NOTICE OF INTENT DRAWINGS

256 FREEPORT STREET

Re: IBEW LOCAL 103 Wetland and Buffer Restoration Plan Updates

Howard Stein Hudson (HSH) is providing this letter update to address comments provided by Conservation Commission Staff in relation to the wetland restoration at the IBEW 103 SITE LOCATED AT 256 Freeport Street, Boston, MA. Also attached is an updated wetland impacts plan and the wetland restoration plan.

WETLAND IMPACT PLAN

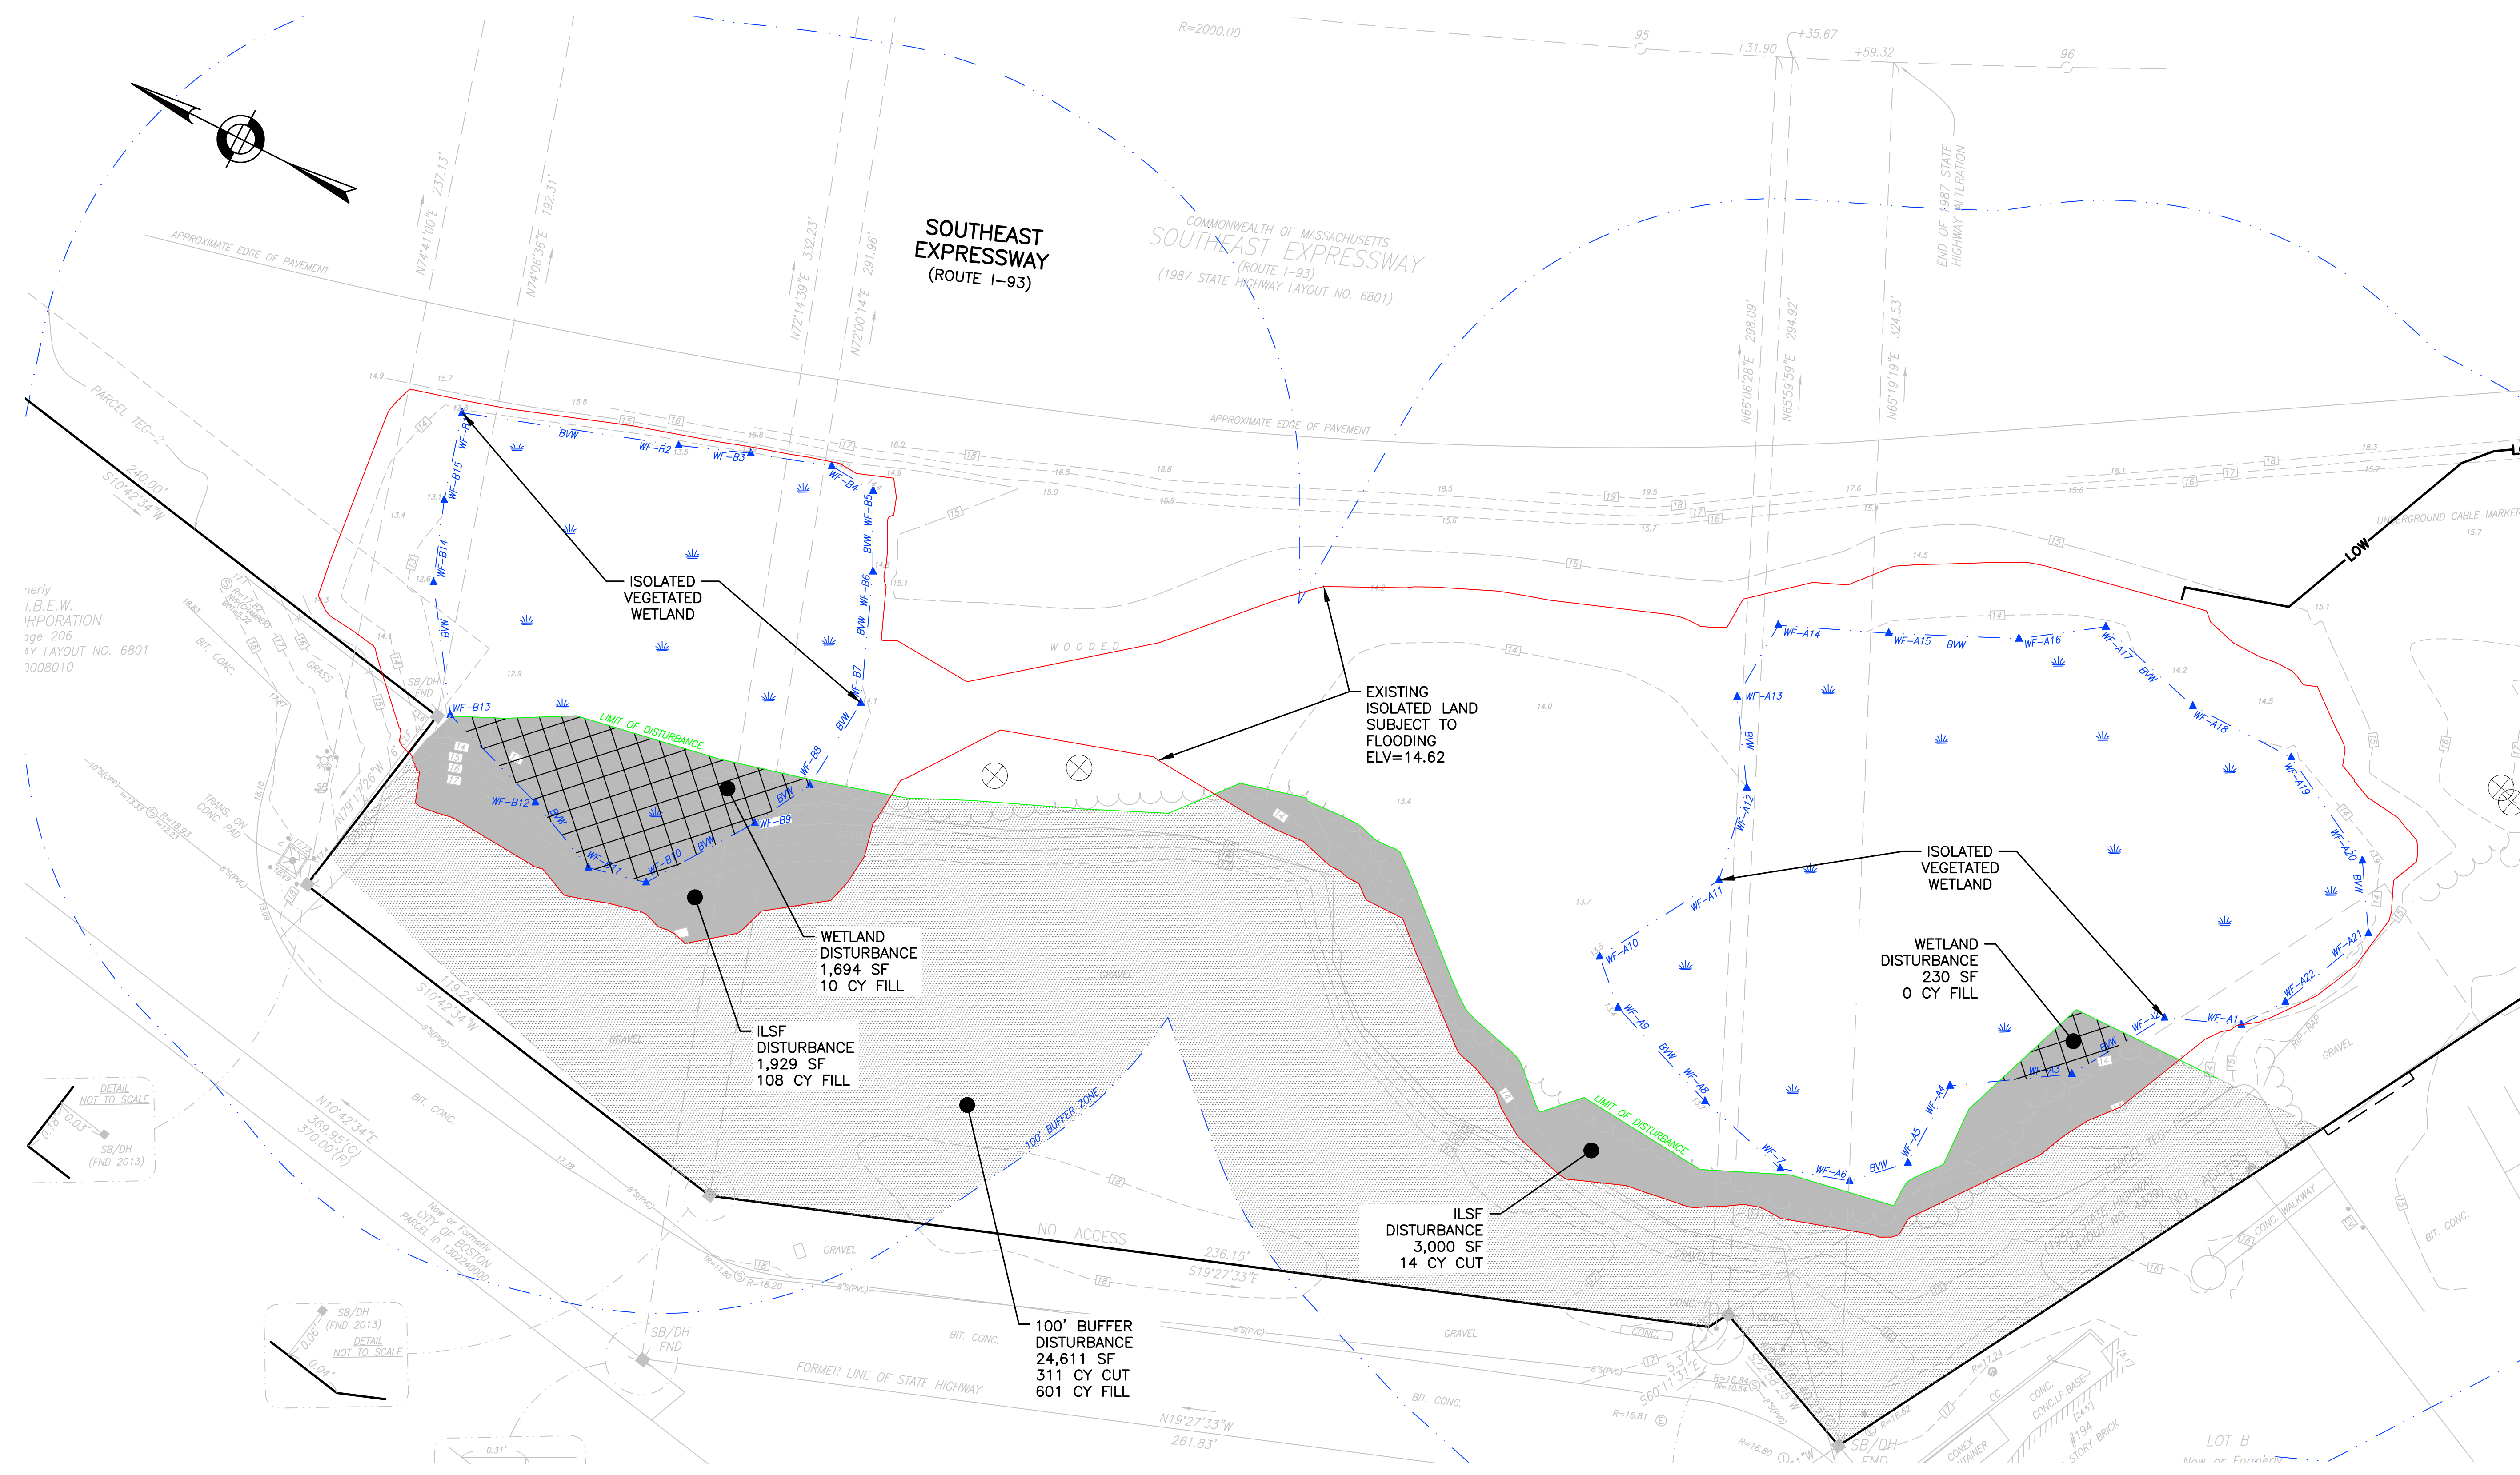
Comment No.1: *Table 1-1 details the calculated impacts to the wetland resources but only quantifies the amount of fill placed within the ILSF. Having been to the site, a substantial amount of fill has also been placed within the IVW and Buff Zone. Why has that not been quantified?*

Response: HSH has quantified the fill within the IVW & the 100-Foot Buffer Zone. An updated table is provided below. An updated wetland impact plan is also attached.
